SERVICE BULLETIN

Ercoupe

No. **105** Date July 1, 1959

Subject: Rudder — Modification of

FIG. 1

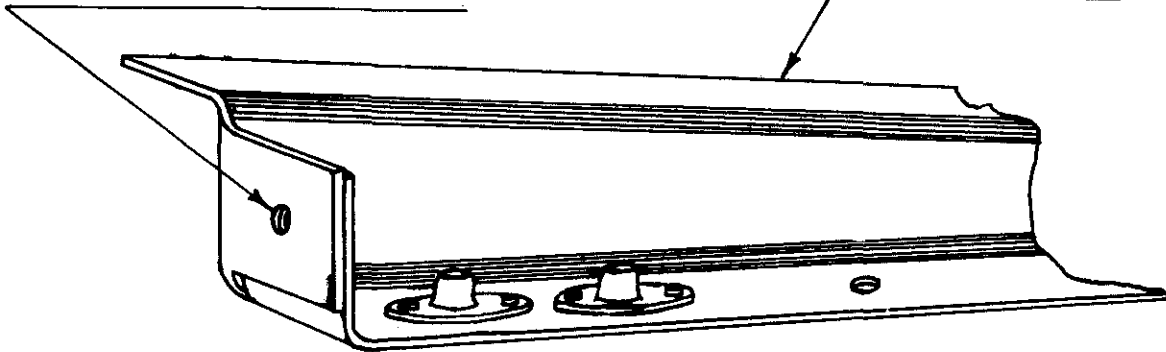
- (a) Back drill #40 hole, "A", at nut plate end of new rib (F-24015), as illustrated in Figure 1.
- (b) It is necessary to trim the stiffener located at the bottom end of the rudder outboard skin as noted in Figure 2. (Note illustrations and procedure before trimming the stiffener.)
 - (1) To trim the stiffener for clearance, it is suggested that four rivets, at the end to be trimmed, be removed.
 - (2) The rib can now be trimmed as shown in Figure 3.

(c) Drill #40 hole through rudder spar by back-drilling through pilot hole "A" in new rib, (nut plate end.)

FIG. 4

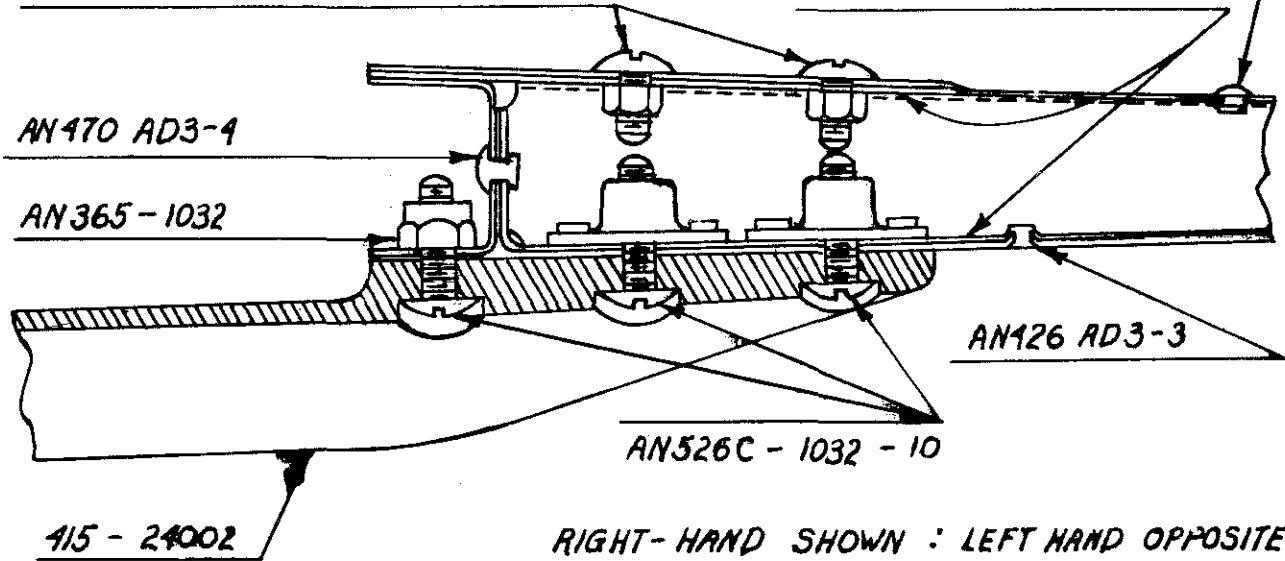
(a) If the rudders were modified per the previous Ercoupe Service Bulletin No. 23, there will be two holes in the outboard skin where the attaching screws of the control horn protruded. To cover these holes, use the two screws (AN 515-6-6) and nuts (AN 365-632) as noted in Figure 4. (Note: If "T" shaped reinforcement was installed in accordance with the previous service bulletin, it may be used for additional strength by attaching it to the outboard skin with the screws used to cover the open holes, or it may be omitted.)

(e) Install the rudder control horn with AN 526C-1032-10 screws, as shown in Figure 4.
